ReImagine Rock Spring

ROCK SPRING MASTER PLAN

Planning Board Worksession #7: March 30, 2017

Rock Spring: Edits to Planning Board Draft

Georgetown Square Shopping Center Page 25

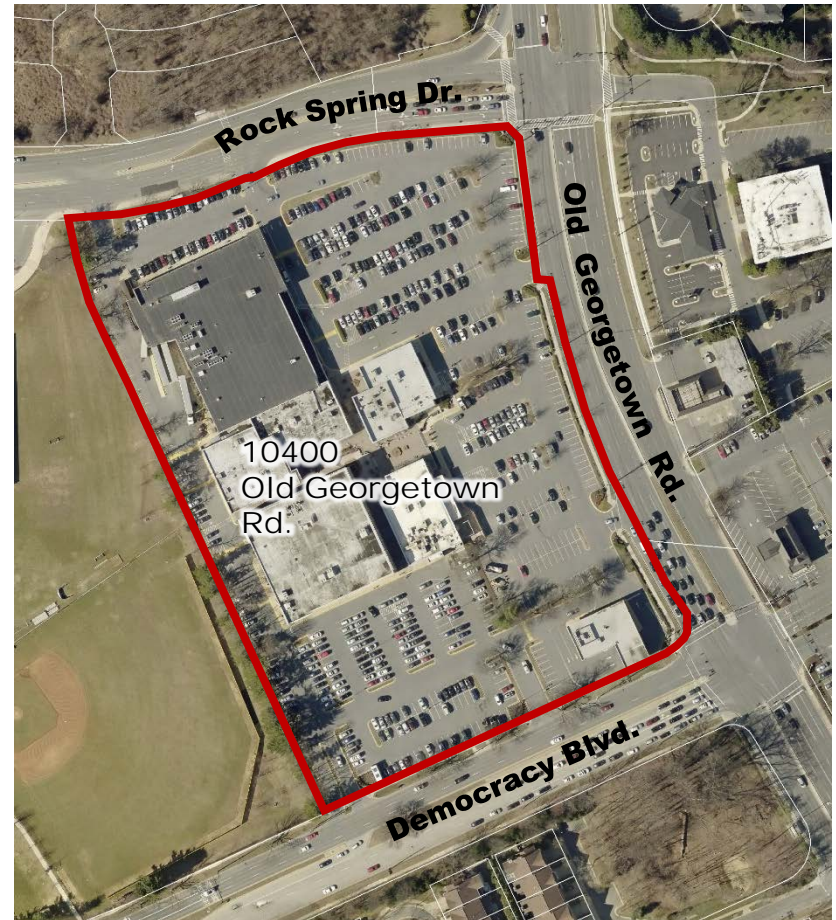
- Rezone the site from NR-0.75, H-45 to CRT-~~1.25~~ 1.5, C-~~0.75~~ 1.0, R-0.75, H-75. CRT zoning for this site would allow the opportunity for a mix of uses to be introduced to this single-use retail area, while encouraging a more sustainable, connected, and pedestrian-friendly development pattern. If this property redevelops, it may be appropriate for a density transfer from the Rock Spring Centre property, located on the north side of Rock Spring Drive.

Existing Zoning: NR-0.75, H-45
PH Draft Zoning: CRT-1.25, C-0.75, R-0.75, H-75
Owner's Request: ~~CRT-2.0, C-1.5, R-1.5, H-75~~ CR-1.5, C-1.0, R-1.5, H-75
Revised Zoning: CRT-1.5, C-1.0, R-0.75, H-75
Potential DUs: 268

Westfield Montgomery Mall
7101 Democracy Boulevard

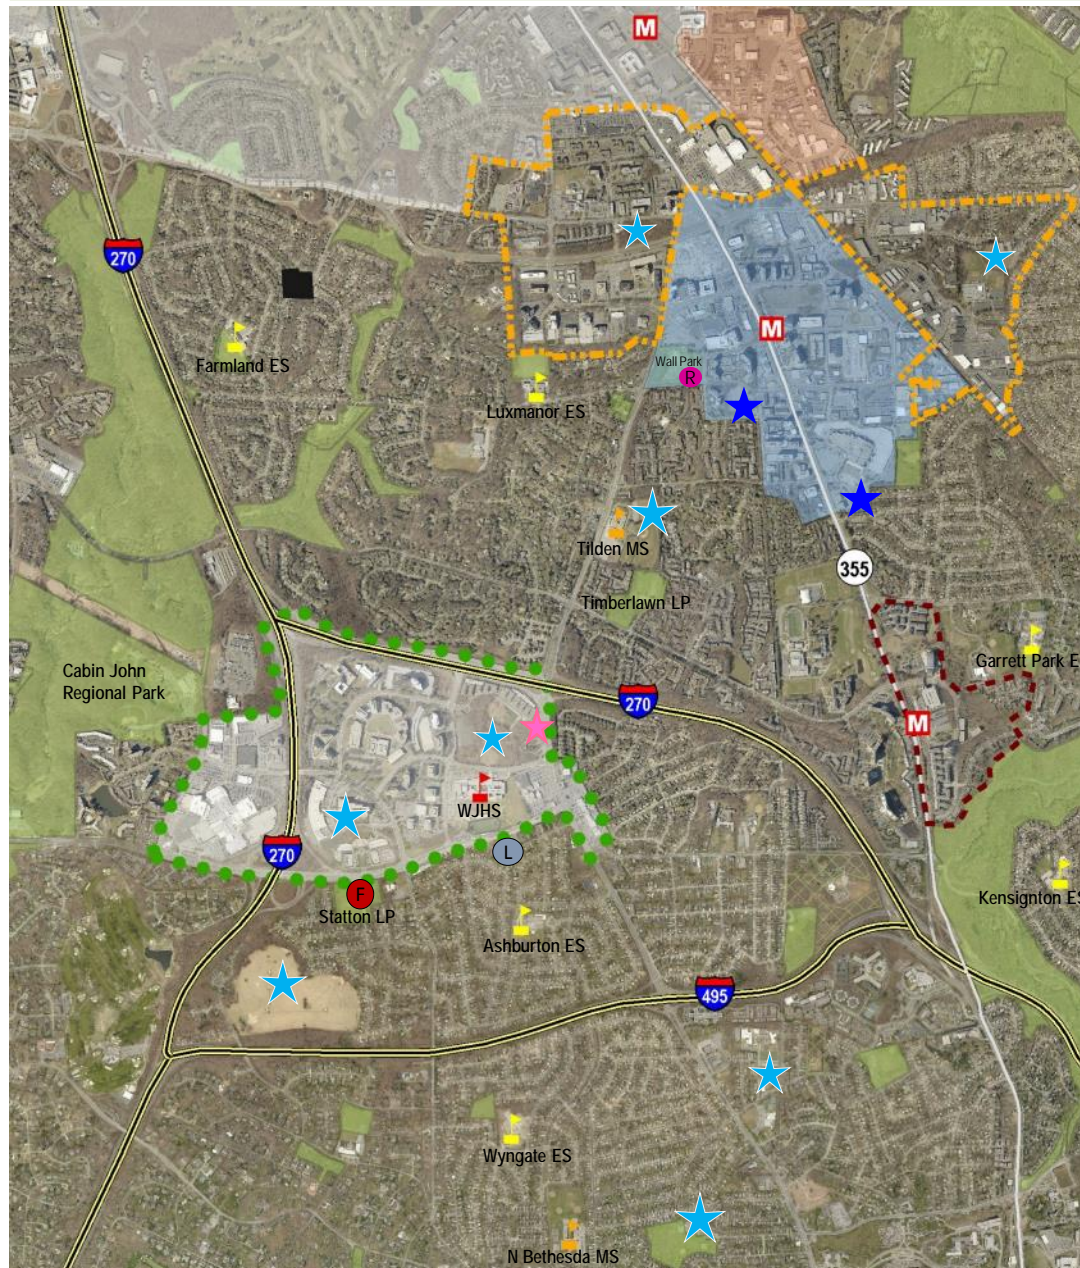
With a Zoning Text Amendment, revise the Regional Shopping Center (RSC) Overlay Zone to clarify that residential uses are allowed and allow additional height (up to 150 feet) to accommodate development of multi-family residential buildings.

Does Planning Board agree to proceed with the ZTA for the Regional Shopping Center (RSC) Overlay Zone?

Staff Response: Support the ZTA

Revised/Proposed Zoning

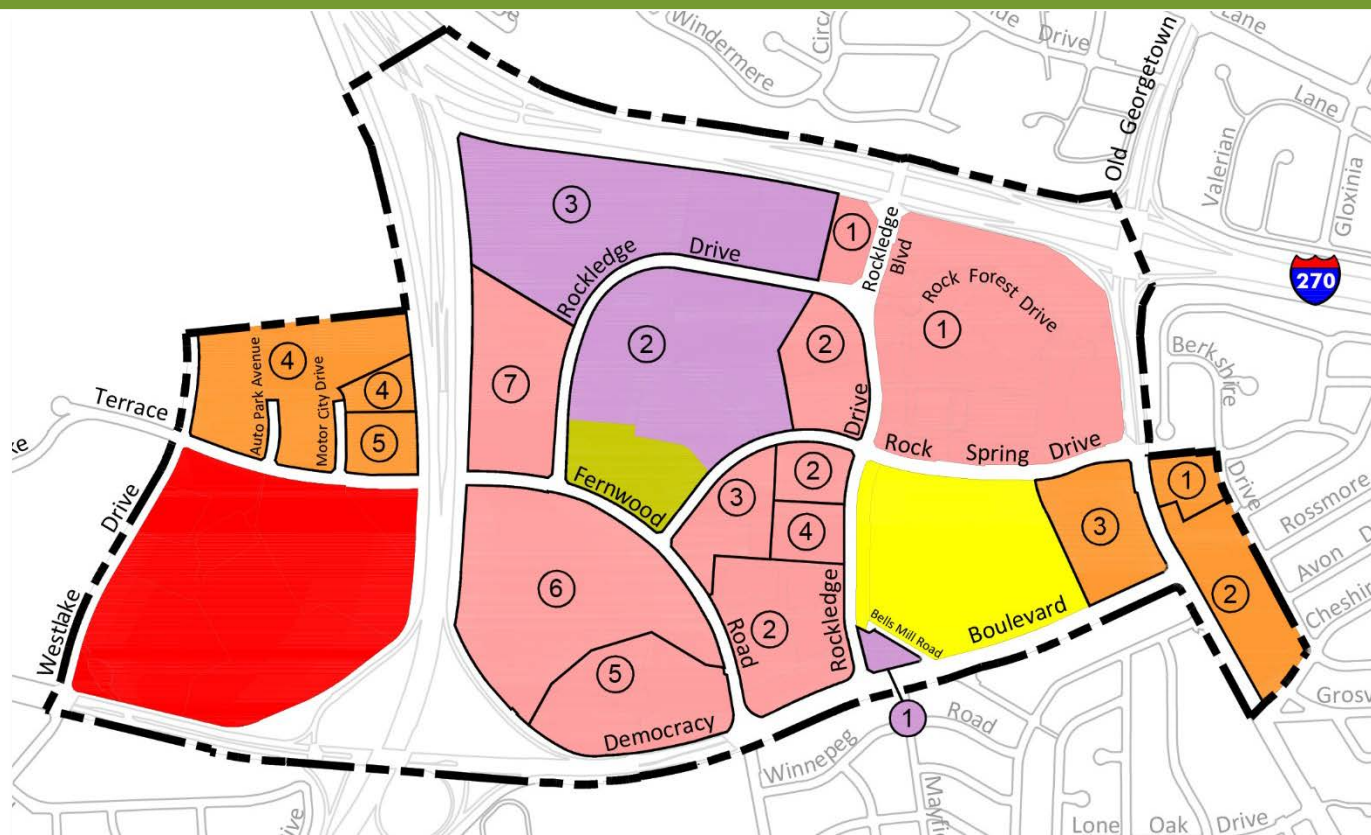
- Revised three cluster area proposed zoning maps to match numbering on Figure 9, overall Proposed Zoning map. Added aerial map with place names next to each zoning map.

Page 49 - Staff recommends editing the last bullet on the page, as follows:

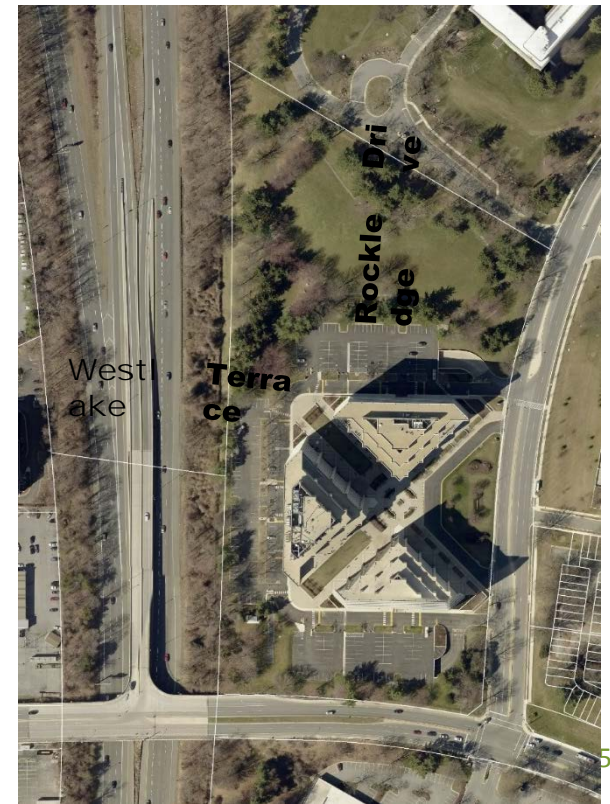
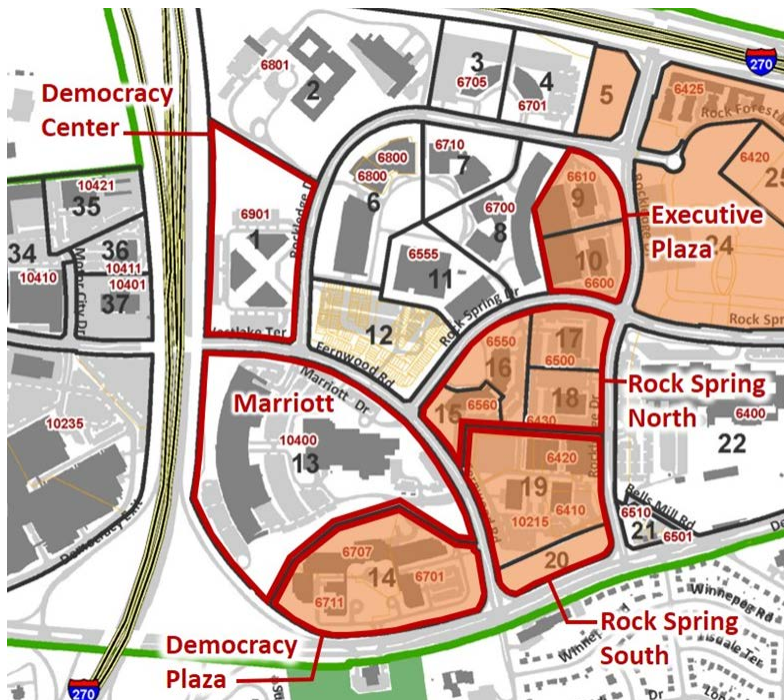
Should the existing structures on the site be razed and the property redeveloped, all or a substantial portion of the open space could be considered for parkland, either through dedication, or acquisition by the Department of Parks.
